**State of Pennsylvania  
Environmental Quality Board**

**Comments of General Motors Corporation  
On the Proposed Rulemaking to Adopt California  
Emission Standards for Motor Vehicles**

**April 11, 2006**

*Figure 1: Breakdown of CARB AB1493 fuel consumption improvements: indicates the contribution of AMTs, downsized turbocharged engines, and Table 5.2-4 vehicle assumptions to the total fuel consumption benefits projected by CARB for the near-term standard-setting.*

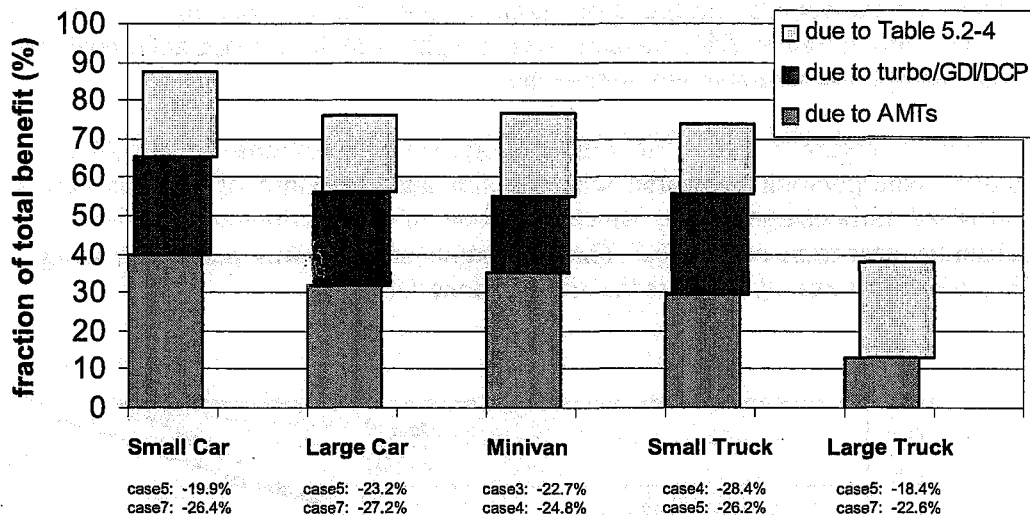
One prominent result of the analysis was that a large fuel consumption reduction was shown for downsized turbocharged engines. In fact, the downsized turbocharged

powertrains served as a standard-setting configuration for all of the vehicle segments except one in the near-term calculations, as shown in Figure 1.

There are serious concerns with the methodology used to arrive at the chosen set of downsized turbocharged powertrains. These concerns are related to the real-world driveability performance of the proposed downsized turbocharged powertrains. Of specific concern is vehicle “launch” performance, which captures the initial acceleration characteristics of the vehicle from a stopped position. Also of concern are the transient response and driveability capabilities of the downsized turbocharged powertrains.

Figure 2: AVL simulated acceleration results for minivan vehicle segment, showing baseline and case 4 (the downsized turbocharged case)

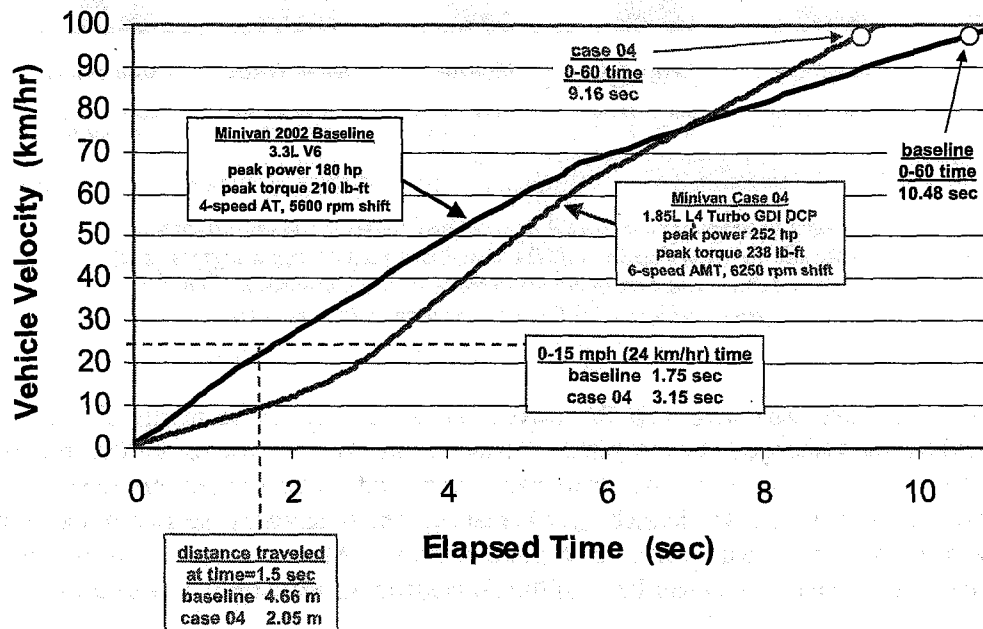
The plot in Figure 2 shows the simulated acceleration response of the 2002 baseline minivan configuration compared with the simulated response of minivan case 4 (the downsized turbocharged case, which was one of the configurations used to set the California near-term standard). The simulation analysis was performed using AVL-CRUISE, and it exactly matches the analysis done for ARB.

It is evident from Figure 2 that the launch and early acceleration response of the downsized turbocharged powertrain for minivan case 4 is much worse than the baseline powertrain in terms of capability. Even though the 0-60 acceleration of case 4 is faster than that of the baseline, the performance lags when the vehicle is below 47 mph (75 km/hr). In case 4 it takes an engine with 252 horsepower to match the 0-60 time of the baseline 180 horsepower minivan engine! The unrealistically high horsepower value required for a baseline minivan engine is an indication that the balance of low-end torque and peak power for the powertrain is not realistic. Since the baseline case was chosen to be representative of the minivan class of vehicles, it is fair to state that the performance

expectation for minivan customers for launch and early acceleration is not being met by minivan case 4.

Also highlighted in Figure 2 are some typical metrics regarding launch performance: 0-15 mph time and distance traveled at 1.5 seconds. Various manufacturers and powertrain developers use their own metrics, which may be slightly different, but those shown in Figure 2 are representative of launch. Clearly, minivan case 4 suffers from poor launch.

Figure 3: AVL simulated launch results for baseline and downsized turbocharged vehicles; distance traveled in 1.5 seconds is used as basis for comparison.

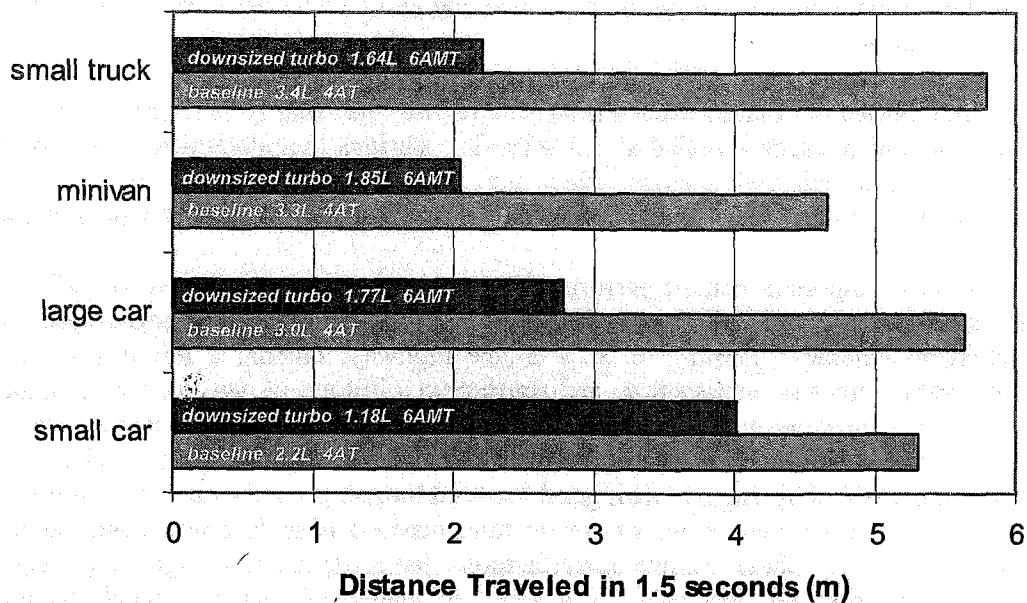
Figure 3 shows launch and acceleration characteristics of the other downsized turbocharged powertrains used to set the California standards. These powertrains were applied to all vehicle segments except large trucks, so they make up a substantial volume (and represent huge production volumes) in the vehicle fleet envisioned in the ARB analysis. As can be seen in Figure 3, each vehicle with a downsized turbocharged powertrain travels significantly less distance during launch when compared to the baseline. In practical terms, when the baseline vehicle has made it through the intersection, the downsized turbocharged vehicle has only traveled halfway through the intersection. It is important to note that the baseline vehicles used here are exactly those chosen by AVL and ARB: vehicles representative of what is saleable in the competitive marketplace. *Any degradation from these baselines – let alone the huge degradations shown here – is a degradation in performance and contradicts the ARB assertion that vehicle performance was maintained.*

Another observation resulting from Figure 3 is that the heavier vehicles (trucks, minivans, large cars) suffer significantly more degradation in launch when the downsized turbocharged powertrains are applied. The simulation study performed by AVL, while sufficient for a generic comparison of various technology combinations, is not sufficient for standard-setting for vehicles which must meet customer requirements in order to be competitive. ARB states that the study projected baseline vehicle performance, and that their subsequent modeling "maintained those outcomes." This is simply not true.
